LAKE PONTCHARTRAIN, L.A.
AND VICINITY
**LAKE PONTCHARTRAIN
HIGH LEVEL PLAN**

**DESIGN MEMORANDUM NO. 20
GENERAL DESIGN**

**ORLEANS PARISH
JEFFERSON PARISH
17th. St. Outfall Canal
(Metairie Relief)**

CELMV-ED-PG (CELMN-ED-SP/15 May 90) (1105-2-10c) 3d End
Mr. Eckenrod/ts/5925
SUBJECT: Lake Pontchartrain, Louisiana and Vicinity, High Level Plan, Design
Memorandum No. 20 - General Design, 17th Street Outfall Canal

ENCL 23

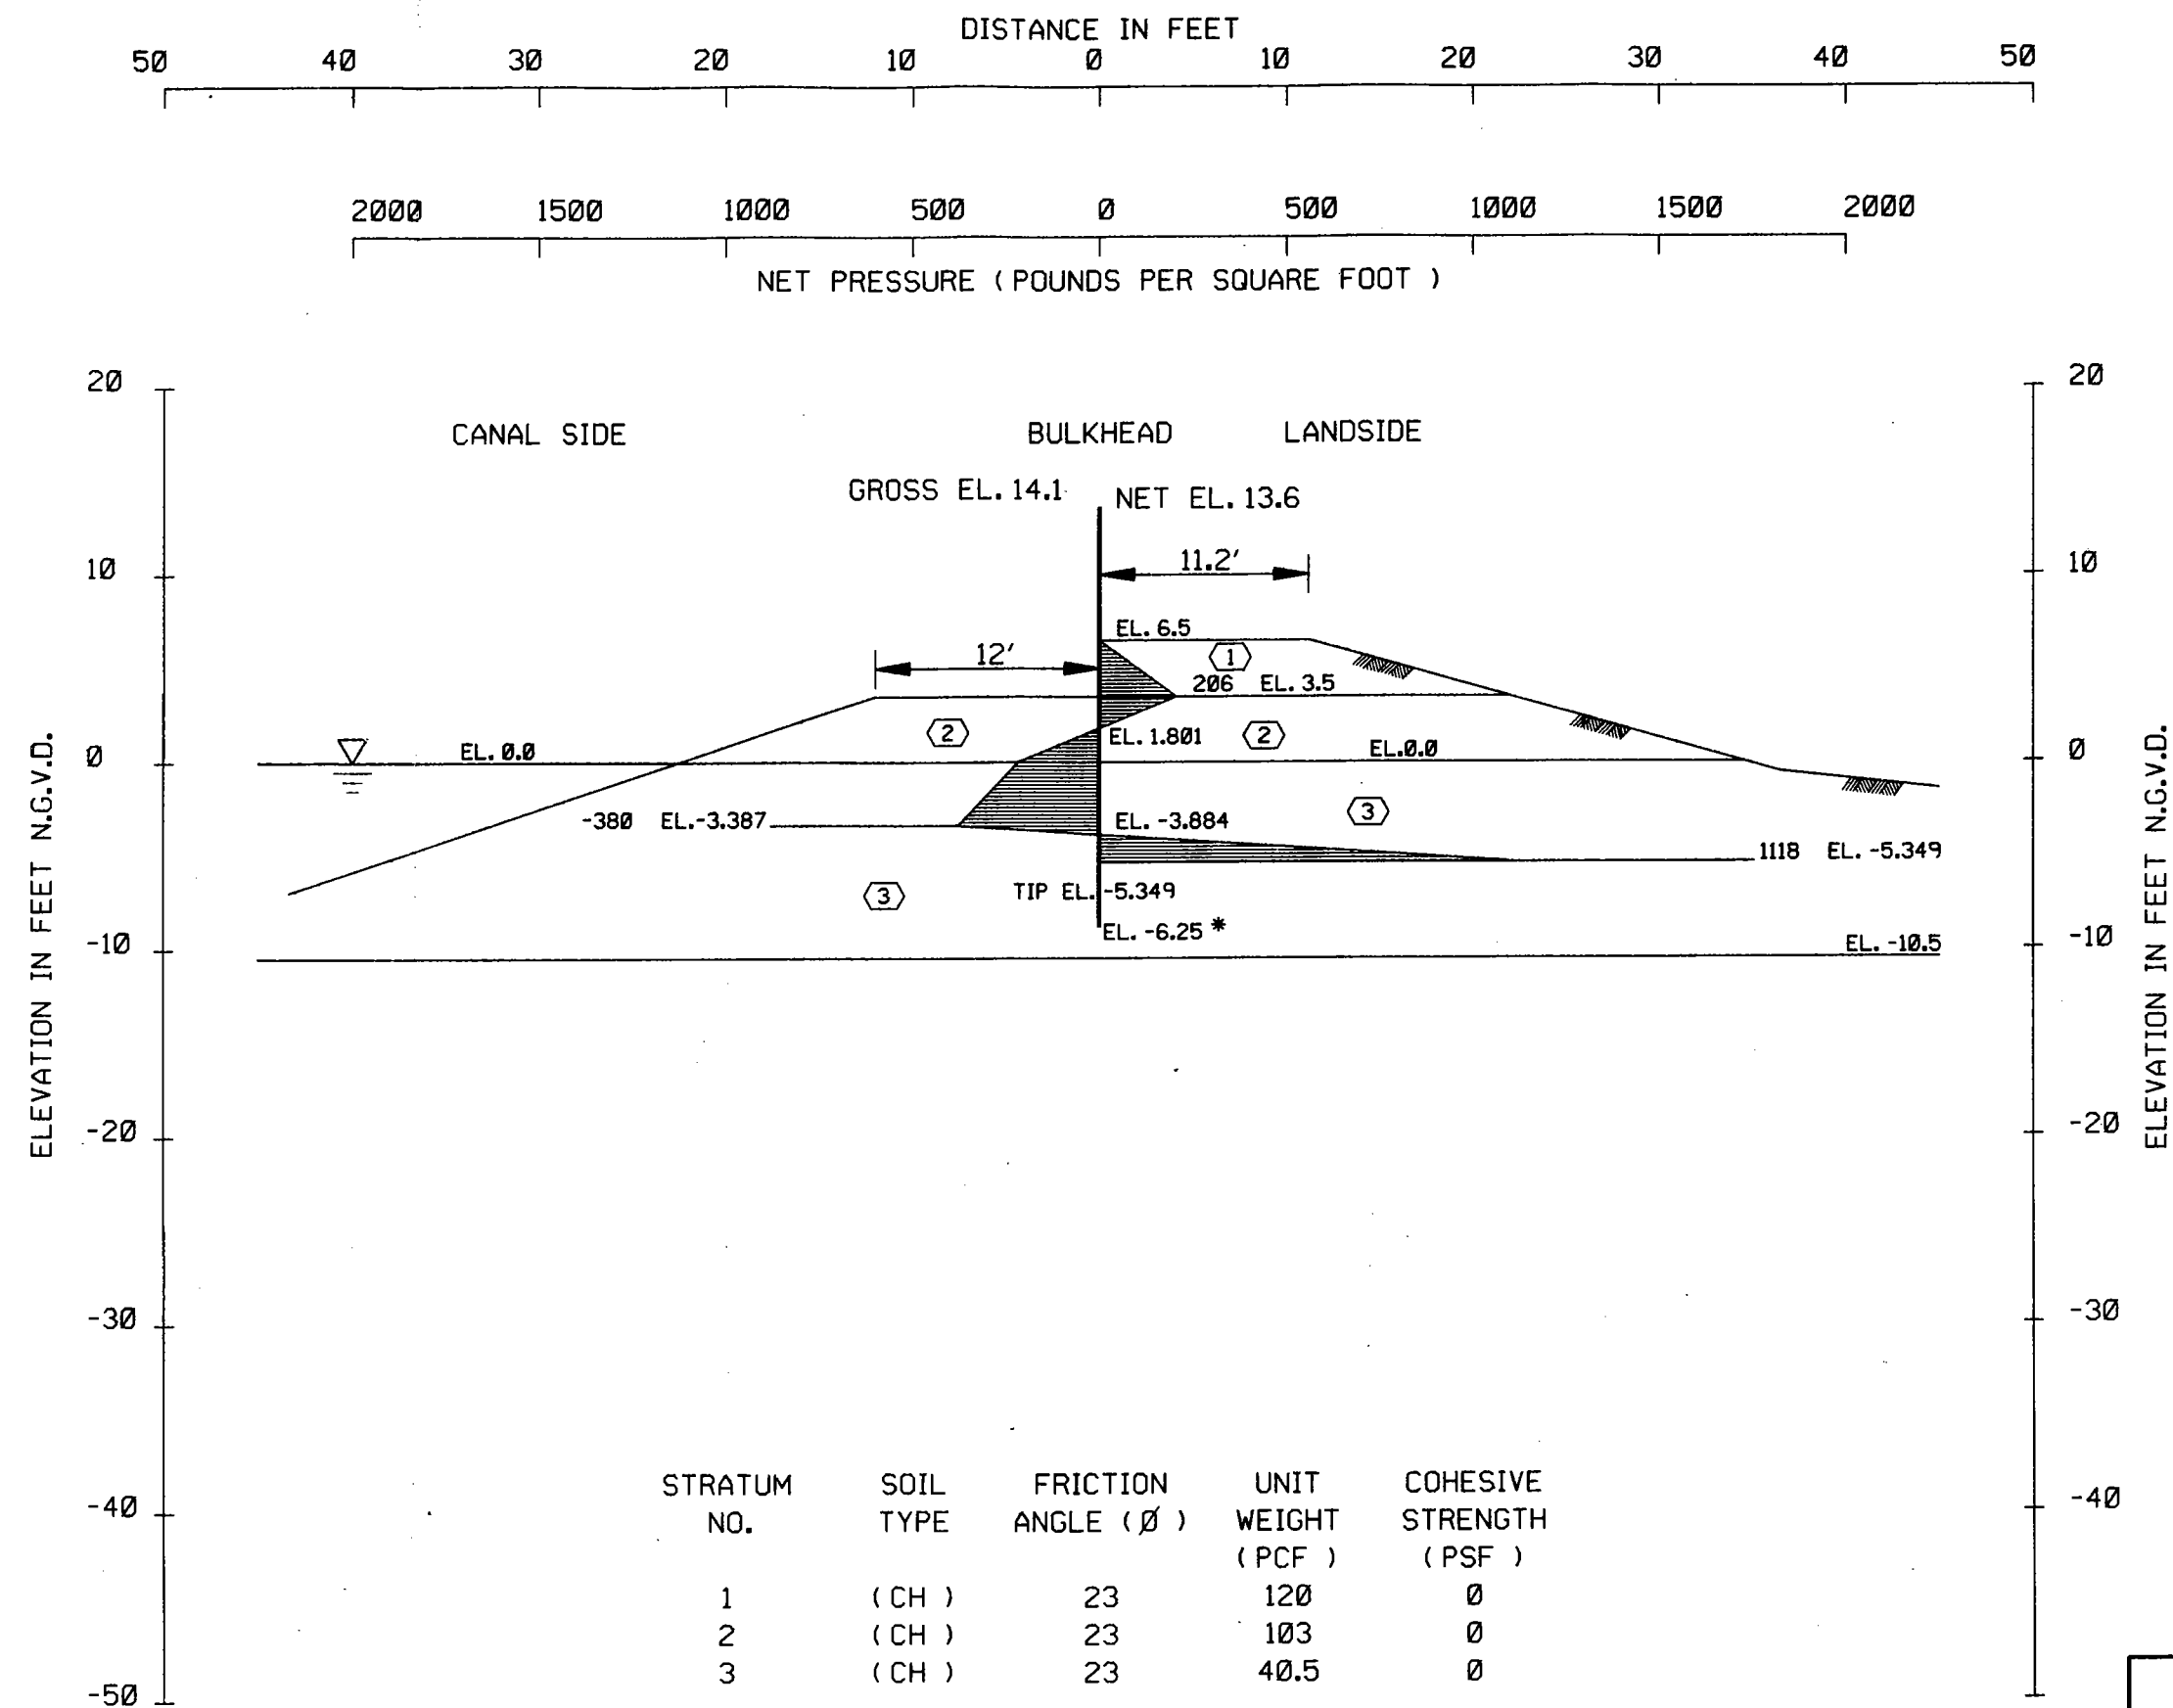
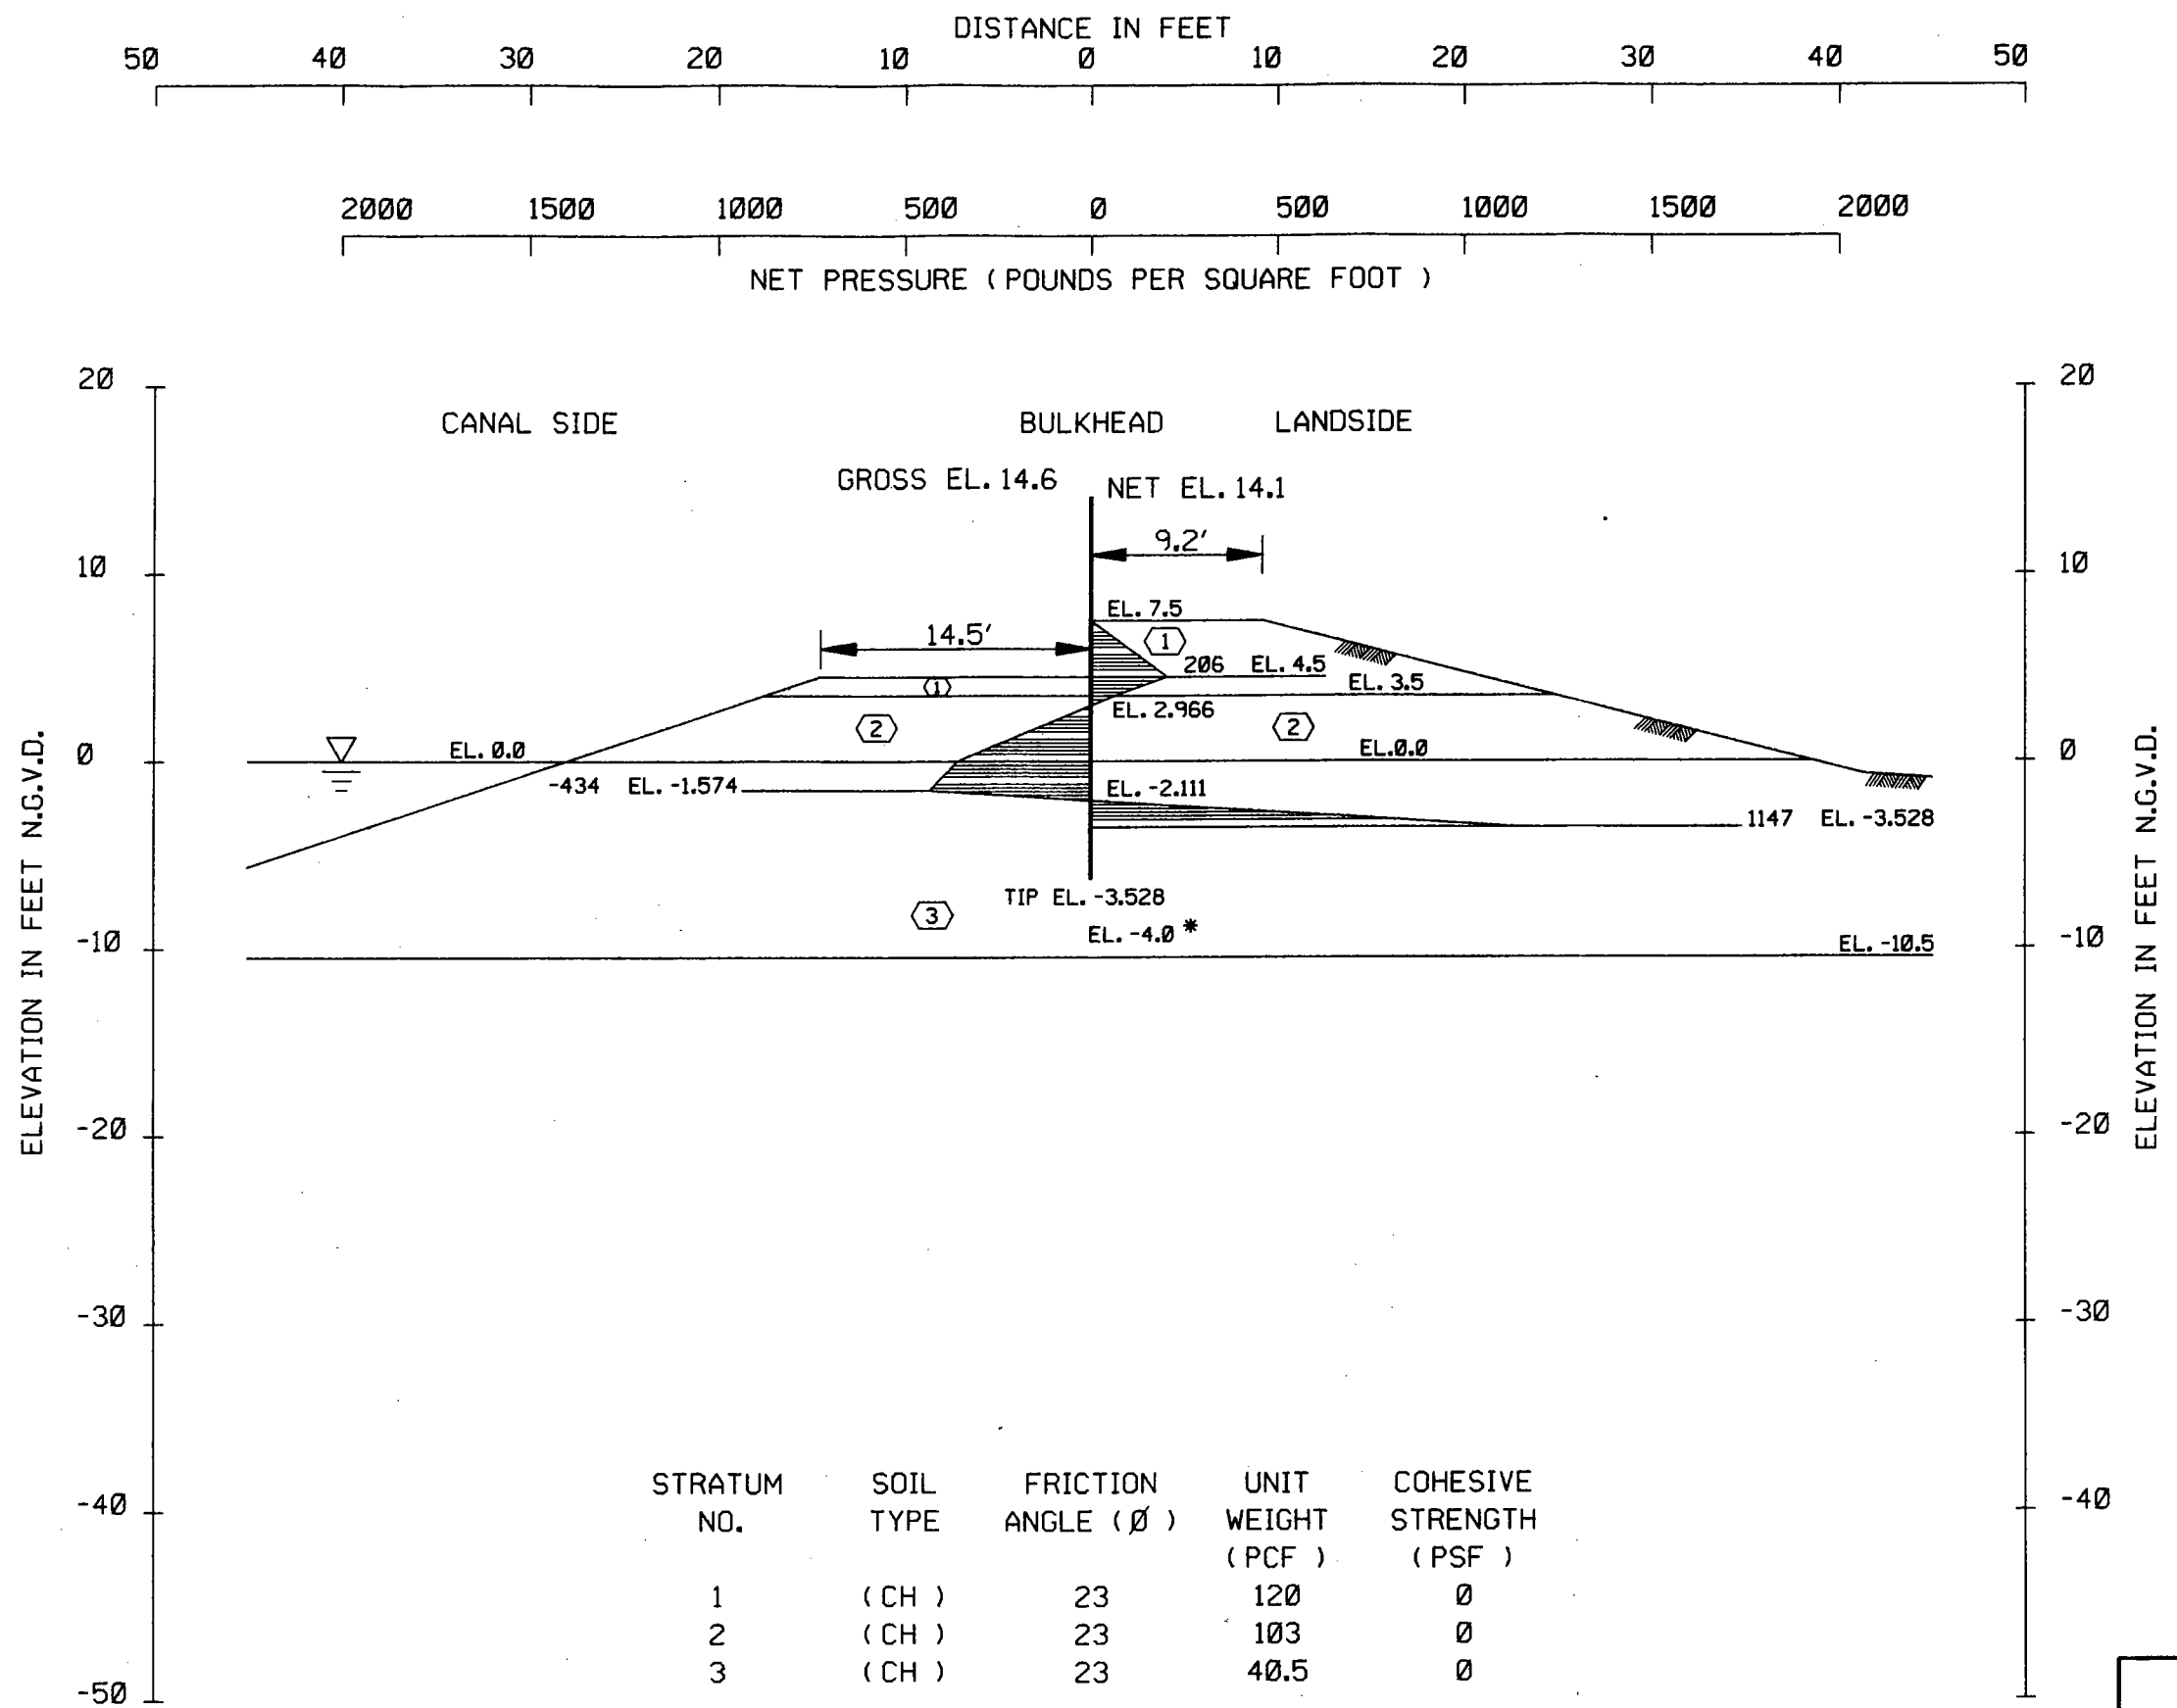
d. Para 29c. Also refer to the tied back and braced wall analyses on Plates 121-124. These analyses are based on the "Q" case soil strengths, a canal level at el -5.0, and a factor of safety of 1.5. Since these sheet pile bulkheads permanently retain soil, they should also be analyzed using "S" soil strengths, a factor of safety of 1.5, and at the normal canal level of el 0.0.

m. Plates 121 through 124. The walls shown on these plates should be evaluated for the anchor forces and resulting stresses on the anchors and the sheet piling should be checked using the conditions shown except change the water level on the canal side to el 0.0 NGVD and use soil properties for the 'S' case and a F.S. = 1.5.

d. Comment d. Para. 29c. The analyses presented were for the Q-CASE soil strengths, a canal level at EL. -5.0 and a factor of safety of 1.5. For plates 121, 122, and 124 the actual design (completed before Dec 87) was controlled by the S-CASE, F.S. = 1.5, and canal level at EL -5.0. The design on plate 123 (completed after Dec 87) was based on the S-CASE F.S. = 1.2 with canal level at EL -5.0; S-CASE F.S. = 1.5 with canal level at EL 0.0; or the 3:1 penetration to head ratio. All the braced walls and tieback walls have been constructed. The tip penetrations shown on plates 122-124 are deeper than the minimum required tip penetration (Encl 3). Intermediate tip penetrations were used to reduce the anchor forces.

m. Comment m. Plates 121 through 124. Concur. Revised plates 121 through 124 are enclosed as Encl 3.
